Staff Report & Recommendation

HPB18-0253, 2899 Collins Avenue - Triton Tower Condominium.

An application has been filed requesting a Certificate of Appropriateness for modifications to the window configurations on all sides of the Triton Tower

Existing Window Configuration (with applied muntins)

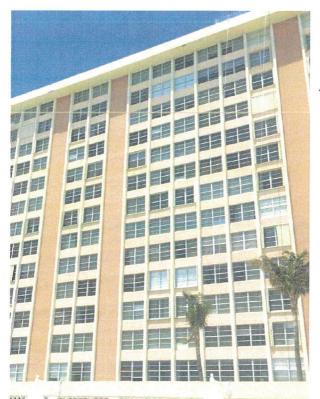
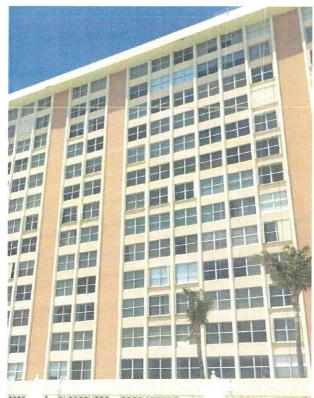
proposed to be replaced with new impact resistant single hung windows. However, the applicant is proposing to eliminate the applied horizontal muntins of both the upper and lower sashes, as shown below.

Staff believes that the proposed modifications will have no adverse visual impact on the Contributing structure. Staff would further note that the Board has previously approved higher levels of alterations of similarly scaled Contributing buildings along Collins Avenue. Consequently, staff has no objection to the proposed alterations and recommends the application be approved.

- 1. Revised elevation, site plan and floor plan drawings shall be submitted and, at a minimum, such drawings shall incorporate the following:
 - a. Final details of the proposed windows and doors, shall be submitted, in a manner to be reviewed and approved by staff consistent with the Certificate of Appropriateness Criteria and/or the directions from the Board. The new door and windows shall have clear anodized aluminum or powder coated light grey or silver frames.
